City of Surrey PLANNING & DEVELOPMENT REPORT Application No.: 7919-0347-00

Planning Report Date: January 31, 2022

BUSINESS PARK **DEVELOPMENT**

Response to ADP comments from January 18, 2021

A-201

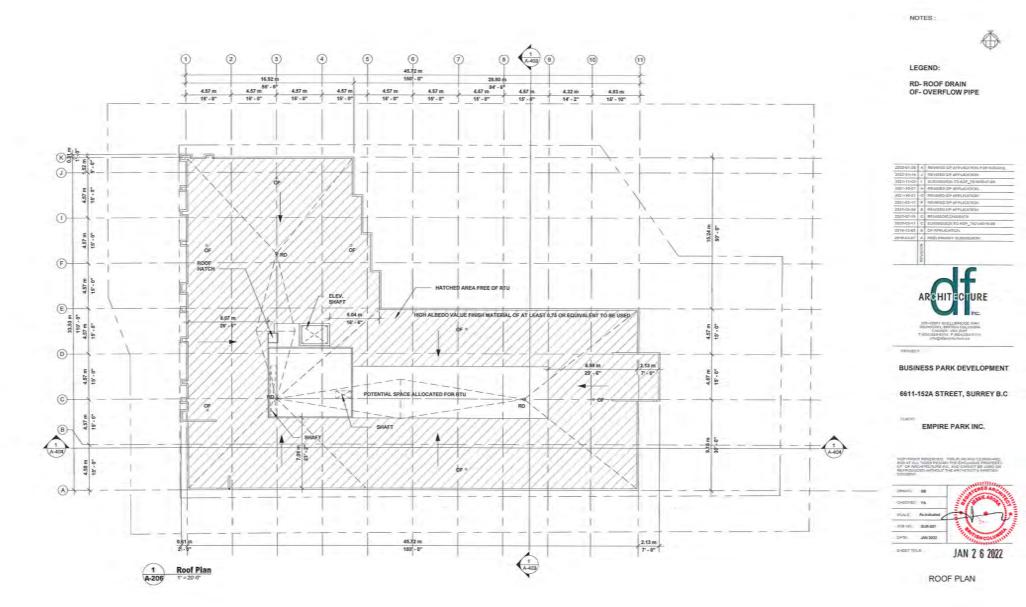
- Use of solar infrastructure will be considered post- Council with involvement of appropriate energy consultants.
 - Consider adding electrical bike charging infrastructure in the end of trip facilities and bike storage areas.

- Bike charging stations have been introduced. See A-201.
 - Encourage providing as much electric vehicle (EV) Charging infrastructure as
 possible for both underground parking stalls and surface parking visitor stalls for
 futureproofing.

- Has been addressed. All parking stalls located at the underground parking and at the undercroft parking are shown equipped with EV charging stations. See A-100 & A-201.
